August 24, 2018

Nell Donaldson, Senior Planner  
City of Portland Planning Division  
389 Congress Street  
Portland, ME 04101

Re: MMC Staff Parking Garage | 222 St. John Street | Level III Site Plan  
Response to Public Comments 2

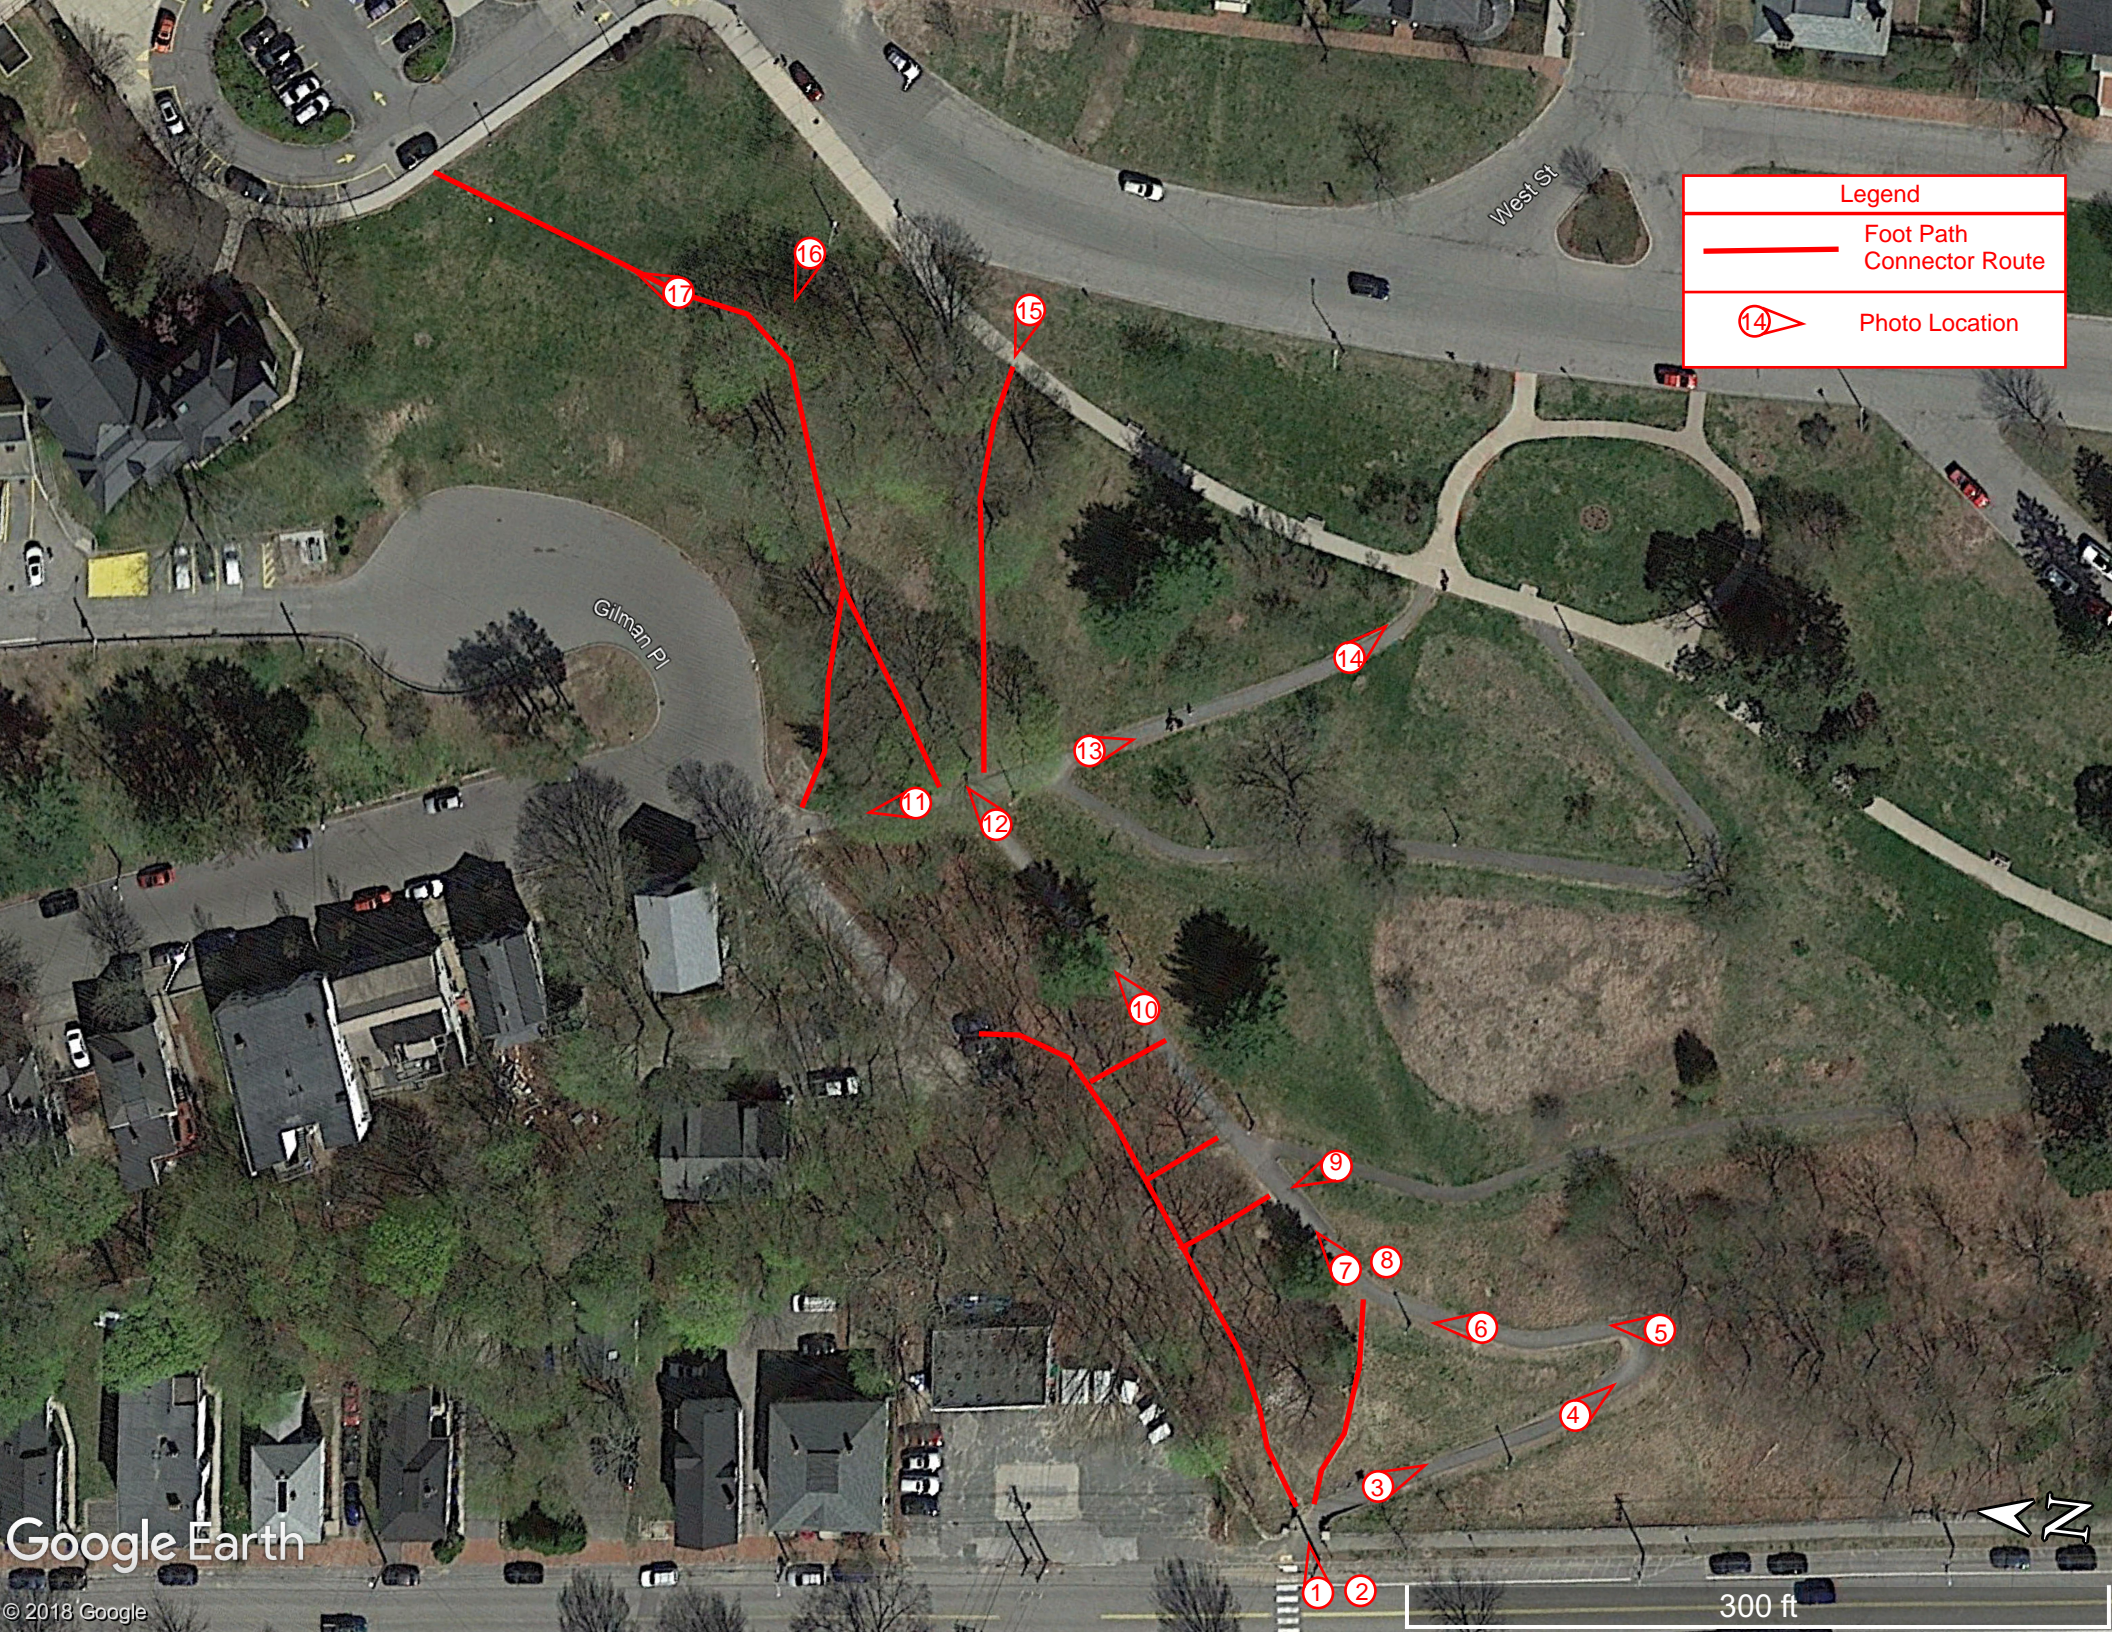
As stated above, the foot path connections show signs of erosion. This is due to the concentration of stormwater runoff funneled down these connector trails with no vegetation to control the rate of stormwater flow. Continued foot traffic compacts the surface further reducing its ability to grow vegetation and slow stormwater velocities. As stormwater flows down grade it begins to channelize within the foot path connectors, causing increased erosion. As the foot path connectors begin to erode the condition is exacerbated as the foot path deepens, further collecting and conveying fast flowing stormwater runoff. The combination of channelized stormwater runoff and the lack of ground cover results in noticeable, moderate erosion and sediment runoff conditions in several areas. The notable area of concern is the foot path connector located to the east of the Valley Street entrance, continuing along the norther edge of the trail towards Gilman Street. Large amounts of trail erosion was observed at the entrance of the Valley Street Trail as shown in Photographs 1 & 2.

To address the drainage concerns at these foot paths we recommend that the foot path connectors be restored to their original intended conditions (field grass or planted trees/undergrowth). Additionally, a

series of stone berm check dams should be installed along the current foot path location to divert and/or slow stormwater flows and prevent further erosion. Please refer to the attached Valley Street Trail Possible Improvements Sketch for further detail.
